Project Name: MONUMENT MORTUARY

STAFF REVIEW

FILE: #SPR 95-218
DATE: December 21, 1995
STAFF: Michael Drollinger
REQUEST: Site Plan Review - Monument Mortuary
LOCATION: 1160 Wellington Avenue
ZONING: B-1

Response to review comments

SITE PLAN

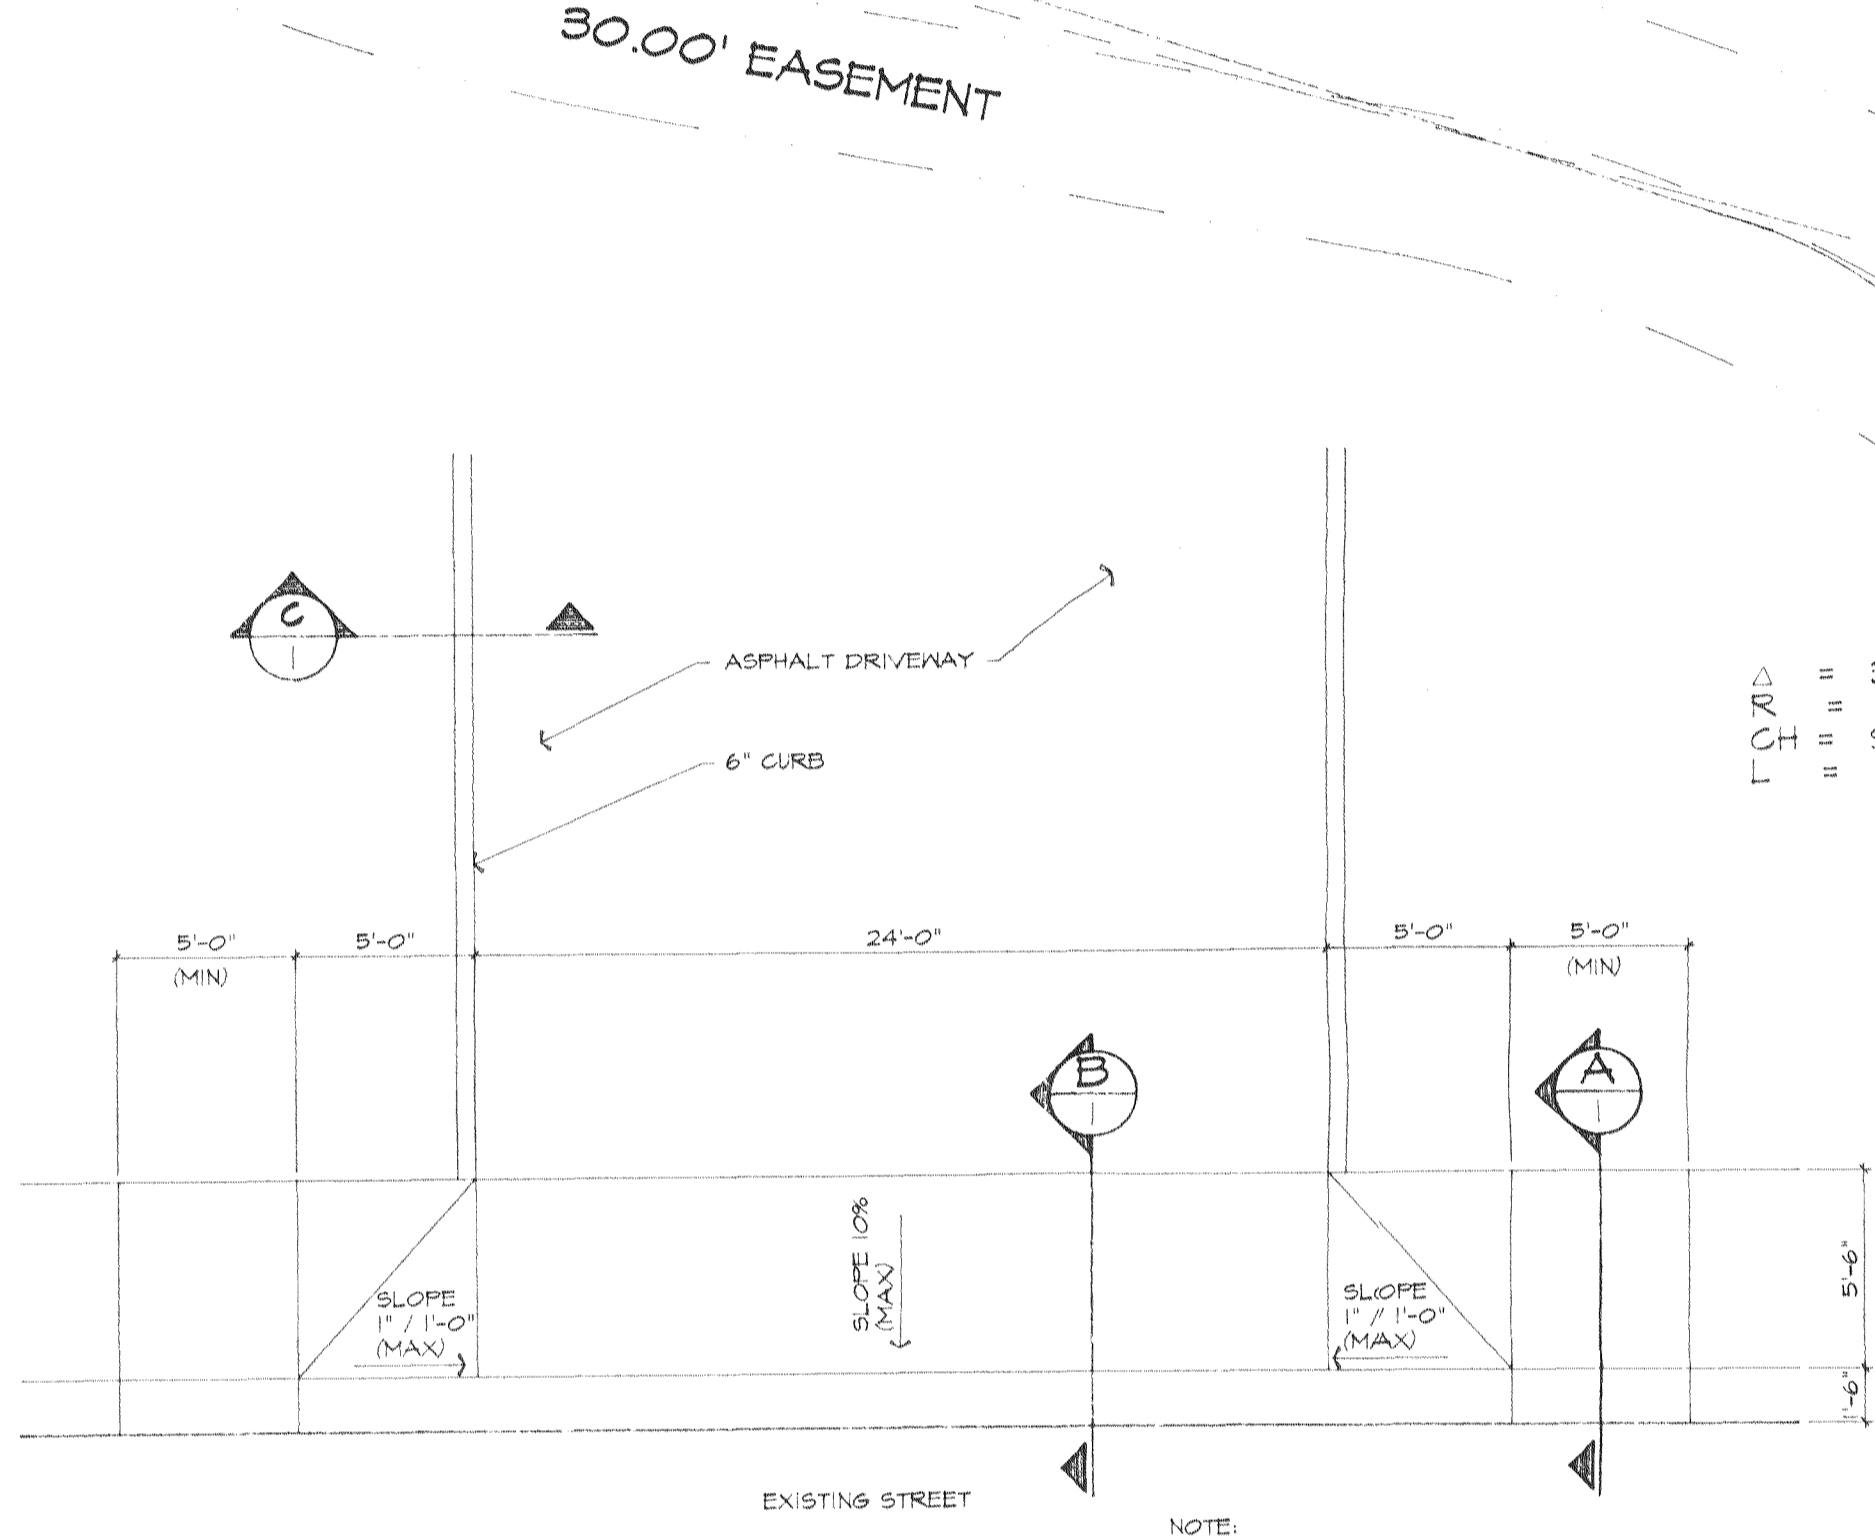
1. No sheet entitled "Site Plan" was provided. Please provide Site Plan sheet and ensure that all information as required by our SSID Manual is clearly identified. I have attached a copy of the SSID checklist for reference. Because of the amount of information shown, the Site Plan and Landscape Plan must be two drawings and may not be combined.

2. Utility information must be on Site Plan, not on Grading and Drainage Plan. Please locate the manhole on plan which exists near the proposed 12th Street entrance. Also locate hydrant on adjoining parcel adjacent to access easement.

3. A breakdown of proposed use of the areas within the building must be provided to determine the parking requirement for the project. The chapel alone requires 50 parking spaces (1 space per 3 seats as per our Zoning and Development Code whereas only 48 spaces are provided). Additional parking will be required for office areas and other uses. As a reminder, a lighting plan will be required if the parking lot exceeds 50 spaces.

4. Improvements within access easement must be detailed on Site Plan.
5. Describe intent of driveway link from parcel to gravel lot adjacent to the medical office building.

- #1 Enclosed please find the revised "Site Plan."
- #2 Please note the corrected information included on the Site Plan, including the location of the manhole and the adjacent fire hydrant.
- #3 Enclosed please find a floor plan for our proposed facility. We believe we have made allowance for required parking.
- #4 Please note the improvements detailed on the Site Plan.
- #5 The driveway link from our property to the gravel parking lot to the north is to provide overflow parking capability for our facility. We would like to reserve the ability to close this access in the event that it periodically creates an unwanted traffic flow during a service or after office hours.

LANDSCAPING PLAN

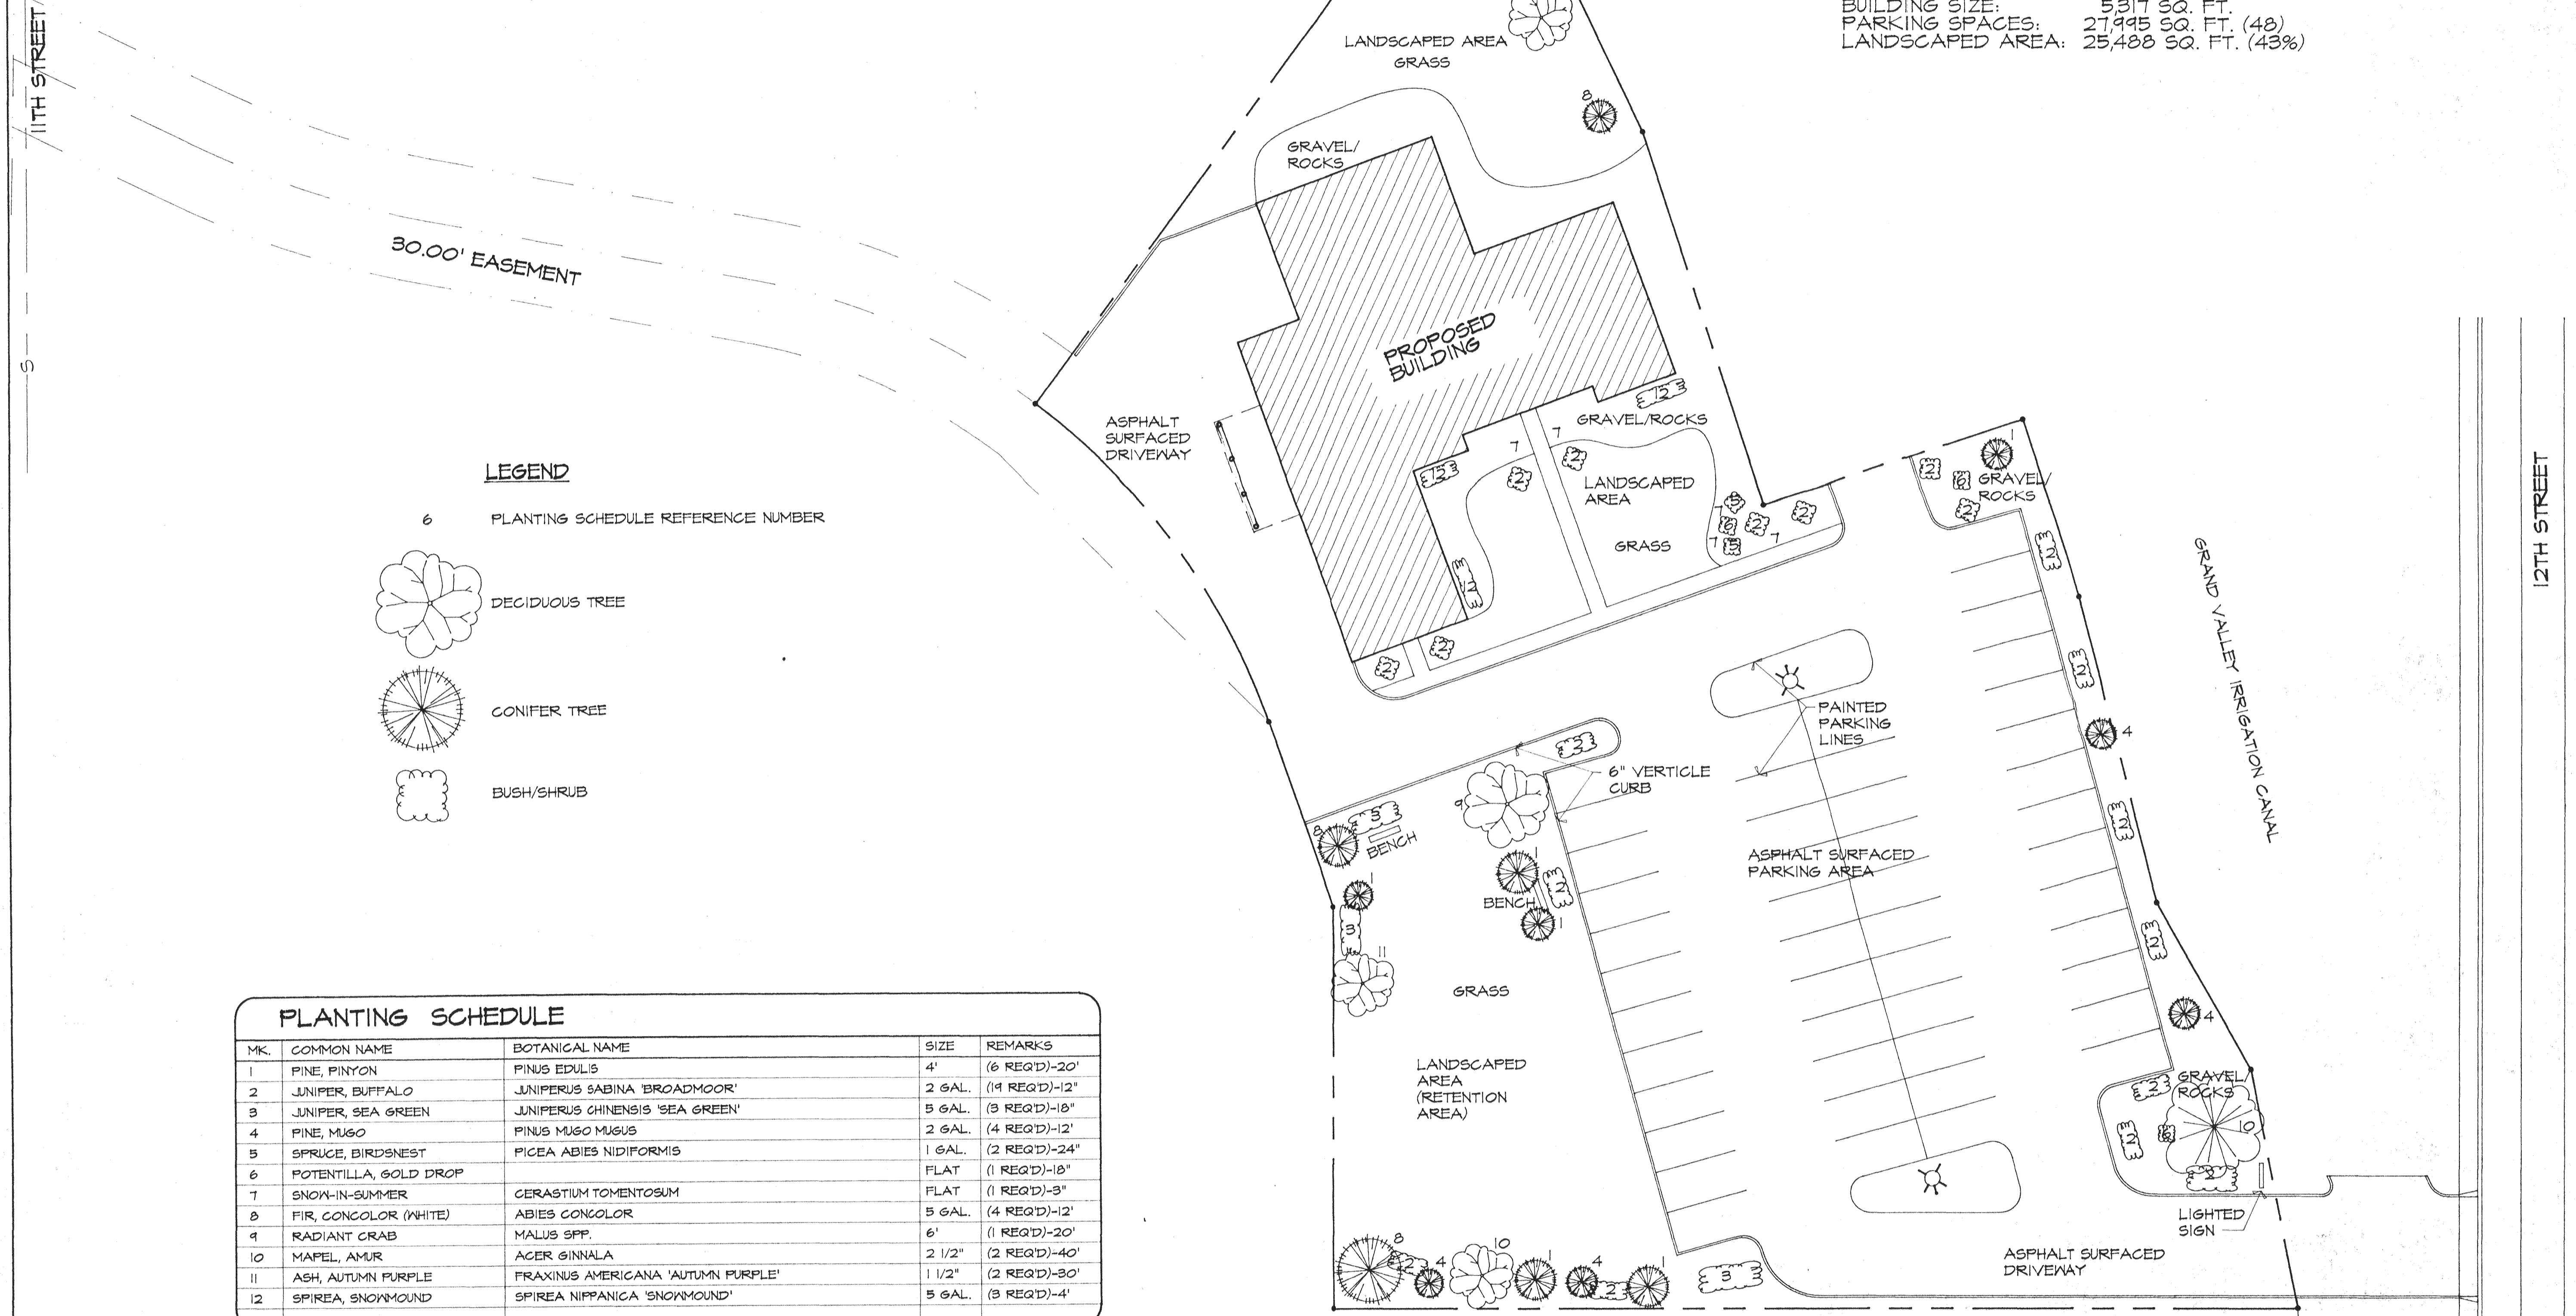
1. Landscape Plan does not meet City's Submittal Standards for Improvements and

Development (SSID) requirements. See attached "Drawing Standards Checklist" for missing items. Deficiencies include: plantings not labeled; quantities not indicated in legend; groundcover materials not identified. This office will conduct a full review of the Landscape Plan once a complete plan is submitted.

2. Please identify all existing vegetation on the site, especially large trees. An attempt shall be made to save as much mature vegetation as practical.

- #1 Please refer to the enclosed revised landscaping plan.
- #2 We are planning on taking out all of the existing large trees. The majority of them are large cottonwoods which have begun to die and pose a hazard if not removed.

GRADING AND DRAINAGE PLAN

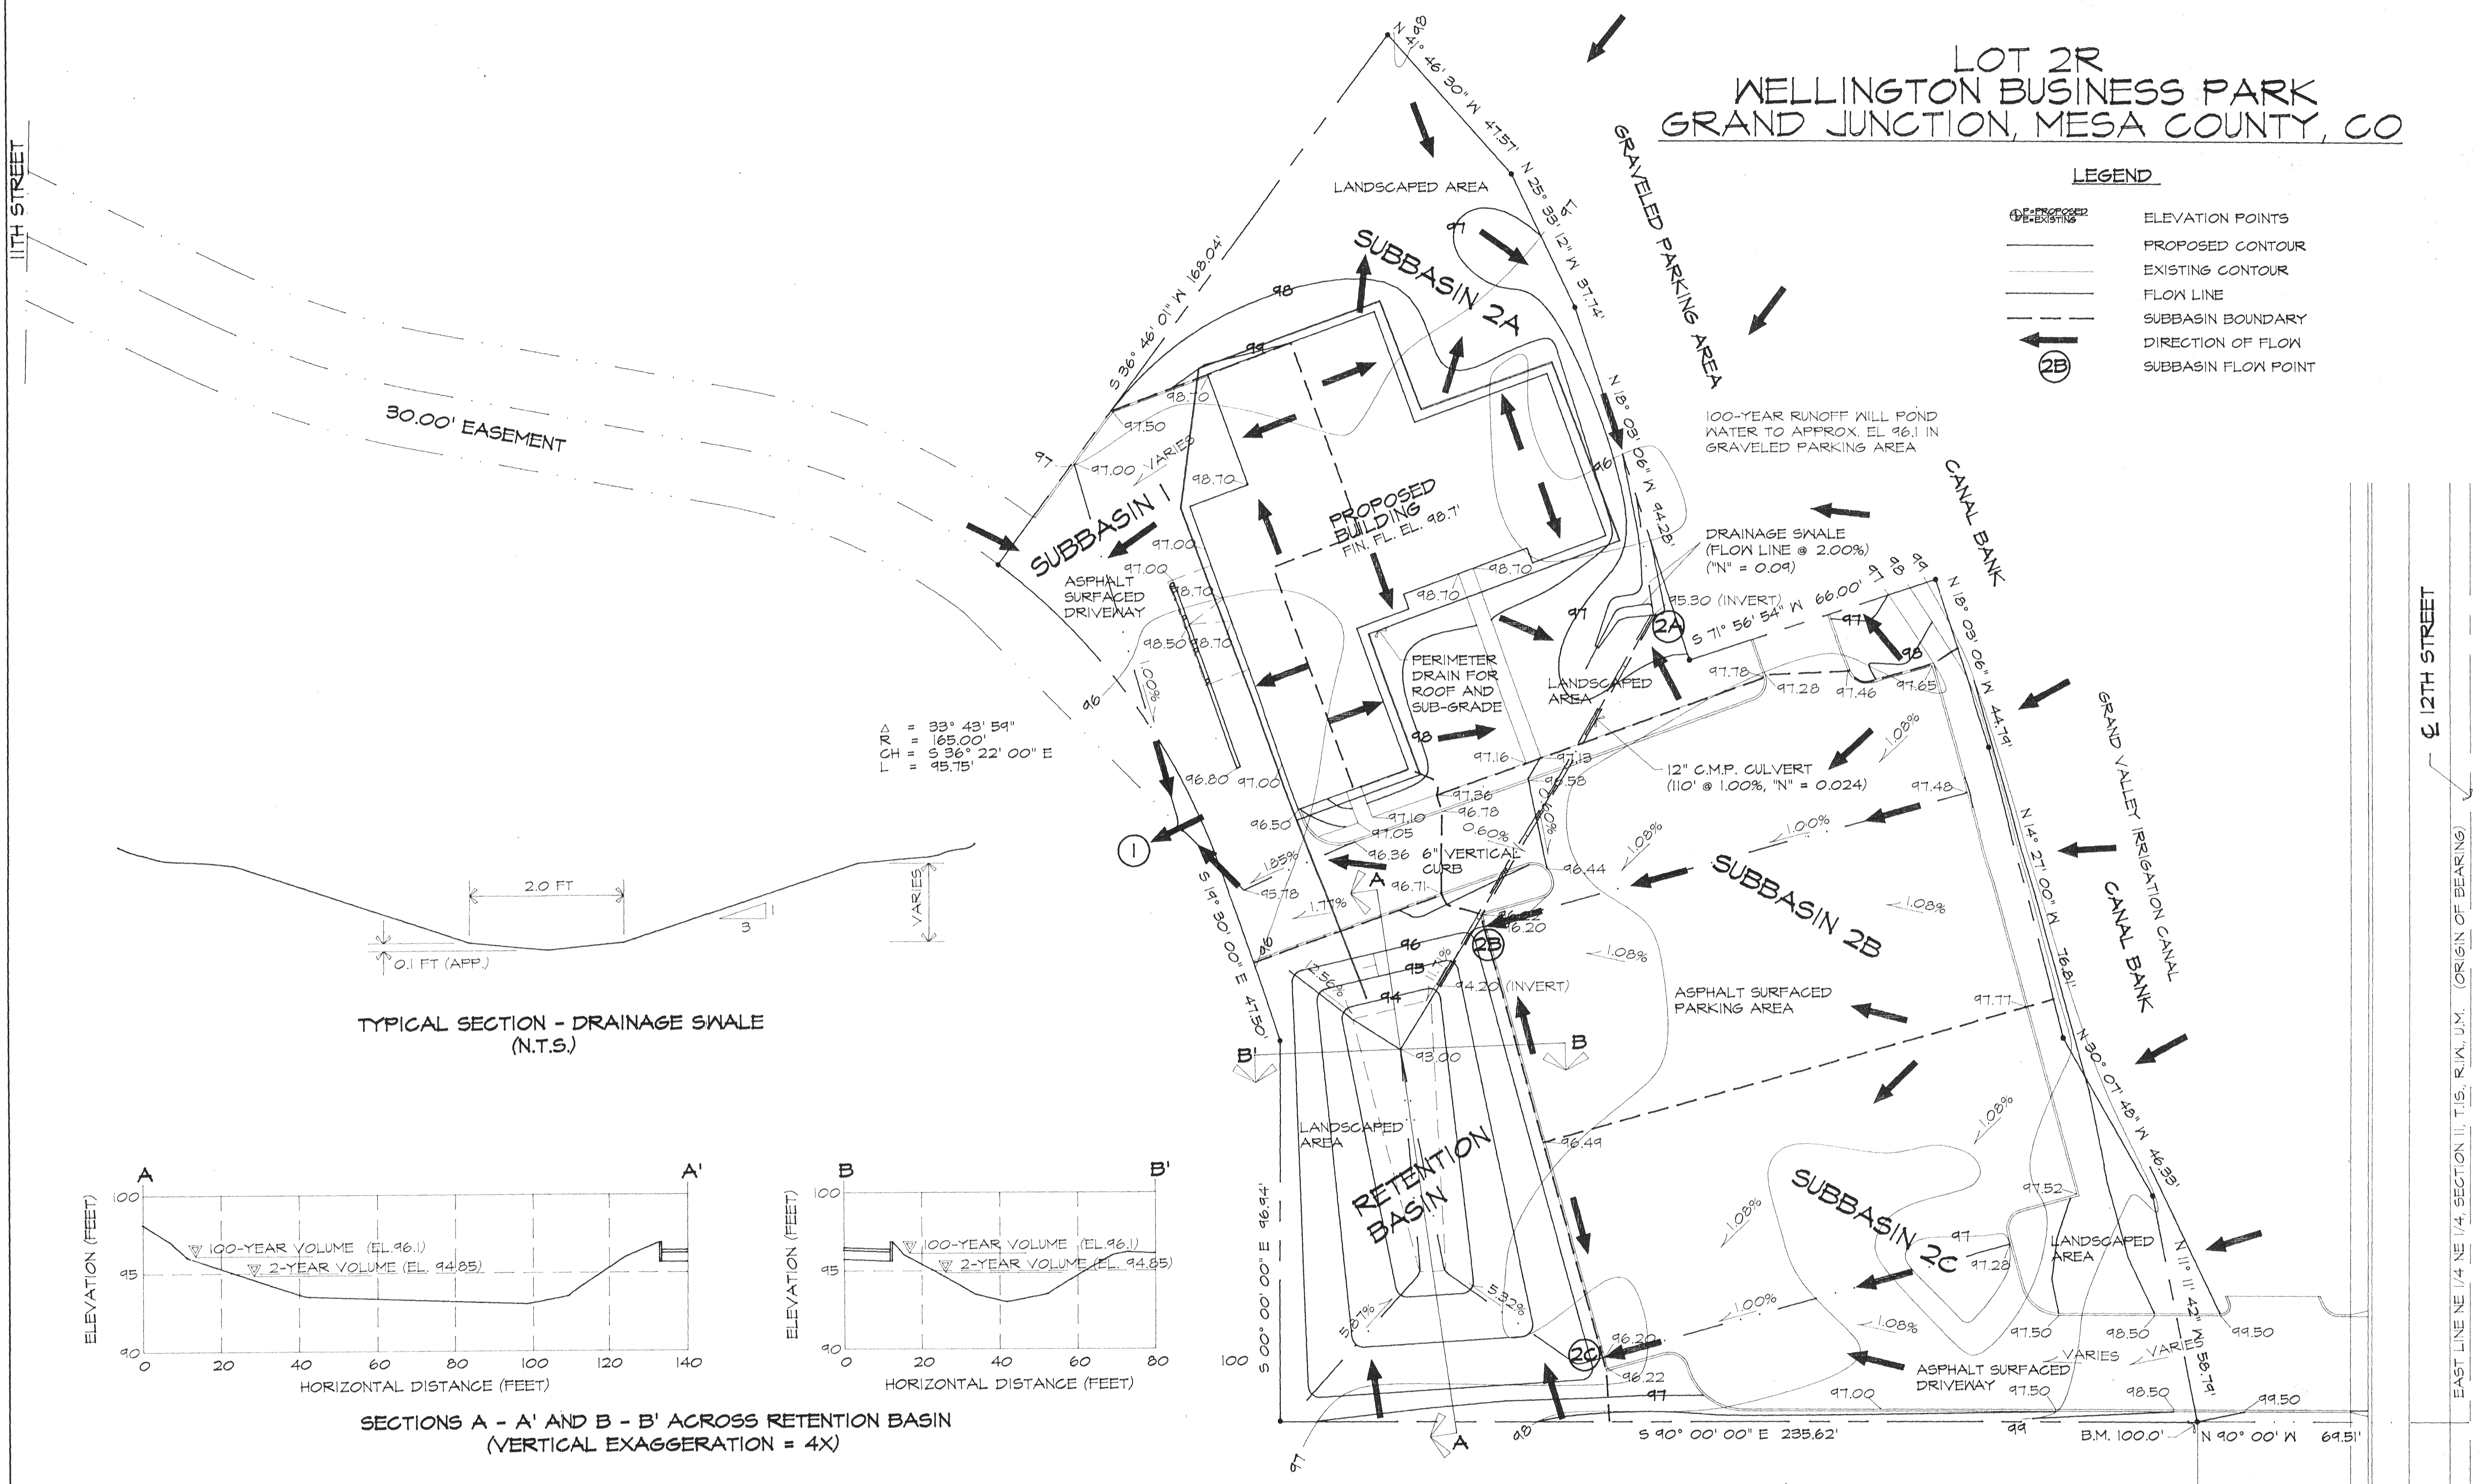
1. The plans do not indicate how much of the existing access road is currently paved. The code requires all required parking and circulation areas to be paved and the access road is certainly part of the circulation area. Please indicate the extent of the current paved area in relation to this plan so an assessment can be made as to how much, if any, needs to be paved.
2. The existing irrigation manhole is now shown on the plans, however, my concern is whether this structure will impede traffic in the driveway. My recollection is that the structure rises above the ground surface by a couple of feet and will be an obstruction to driveway traffic.
3. Revised drainage report and plan are acceptable.
